South Texas Project
Units 1 and 2
Docket Nos. STN 50-498, STN 50-499
Response to Request for Additional Information Regarding Relief Request RR-ENG-3-10 for
Reactor Pressure Vessel Head Flange O-Ring Leakoff Lines Non-Destructive Examination
(TAC Nos. ME9863 and ME9864)

**Response to Request for Additional Information Regarding Relief Request RR-ENG-3-10
(TAC Nos. ME9863 and ME9864)**

Figure RAI-2: Piping and Instrumentation Diagram

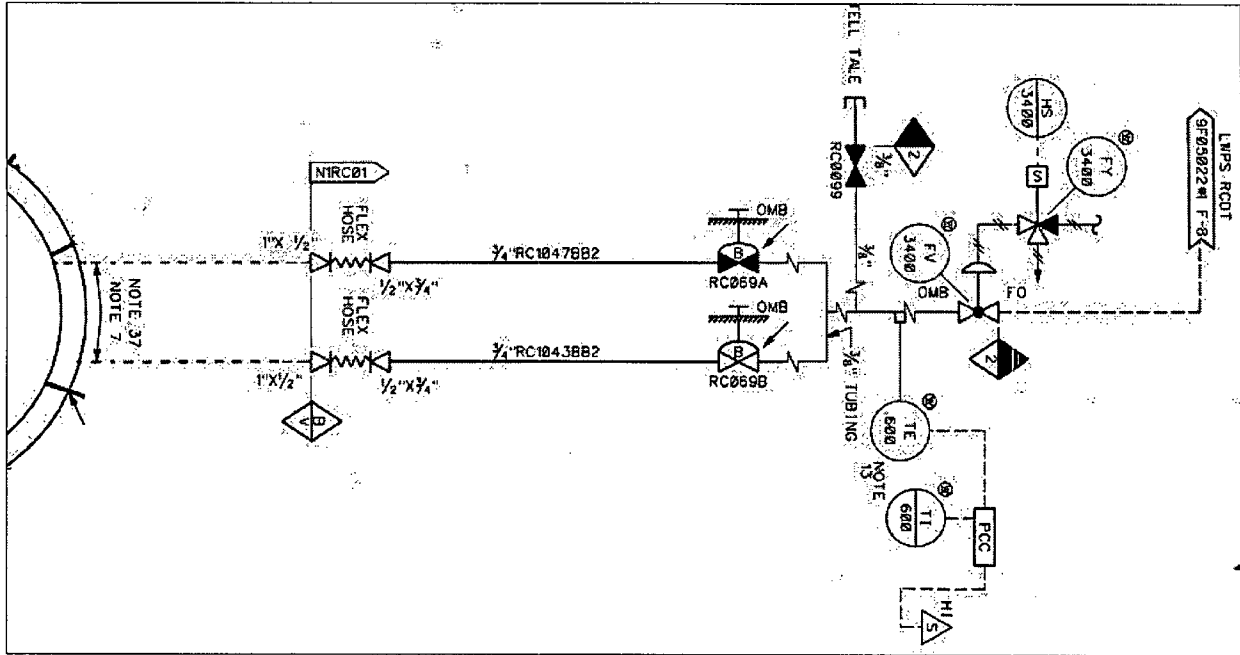
- a. Describe exactly how an operator would visually examine the leakoff line (where and how).
 - b. Confirm that each leakoff line as shown in Figures 1 and 2 consists of a monitor tube of 1-inch in diameter coming off the O-ring area and is connected to a smaller piping of 3/4 inch in diameter.

- b. As depicted below in Figure RAI-2, Piping and Instrumentation Diagram, each leakoff line consists of a 1-inch monitor tube connected to a flexible hose, then to 3/4-inch piping to isolation valves, then to 3/8-inch tubing to the Reactor Coolant Drain Tank (RCDT). The monitor tubes connect to the reactor vessel flange, which contains 3/8-inch passages downstream of each O-ring to collect leakage (refer to Figure RAI-3 below).
